MMPF0100 Errata for Mask 1N47F and 1N18J

This errata document applies to the mask 1N47F, 1N18J SMARTMOS devices.

<table><tr><th>Errata No.</th><th>Erratum</th><th>Customer Impact</th><th>Description</th></tr><tr><td colspan="3"> 
Figure 1. Workaround for ER19</td></tr></table>

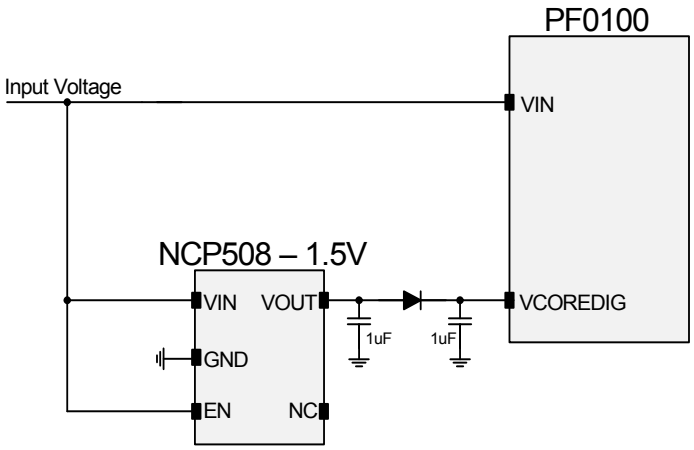
<table><tr><th>Errata No.</th><th>Erratum</th><th>Customer Impact</th><th>Description</th></tr><tr><td rowspan="2">ER19</td><td>Startup:
False start and/or non-start of regulators</td><td>When VIN starts, it ramps up from between 100 mV and 400 mV, the regulators may not startup and/or the buck regulator outputs can glitch high momentarily.</td><td>Description:
In applications without a valid voltage on the LICELL pin, when VIN starts its ramp from between 100 mV and 400 mV, there can be two failure symptoms:
1 Fuses may not load during startup for systems with VDDOTP = 0 V (OTP configuration) resulting in non-start of all PF0100 regulators.
2 During VIN ramp up, the top P-MOSFET of buck regulators may turn on while 1.0 V ≤ V_{IN} ≤ 2.1 V. For VIN rise times less than 10 ms, buck regulator outputs can rise up to 1.0 V as VIN transitions from 1.0 V to 2.1 V. For VIN rise times greater than 10 ms, buck regulator outputs can rise up to 2.1 V as VIN transitions from 1.0 V to 2.1 V.
Workaround:
The workaround consists of external components. Refer to Figure 1.
• LDO: 1.3 V to 1.5 V LDO. NCP508 or similar. The LDO should have an enable threshold of 0.9 V or lesser and a turn on time in the order of 10 μs.
• Diode: BAS116 or similar. Diode is not required if no coin cell is present at LICELL. Only one 1.0 μF is required if no diode if used.
Notes:
1. Previously SIP21106, LX8211, MIC5205 or similar LDOs were suggested as workaround. While these will prevent symptom 1) mentioned above, they may not prevent symptom 2) since their enable threshold is above 1.0 V.
Applies to:
PF0100
Fix Plan/Status
Fixed on PF0100A</td></tr></table>
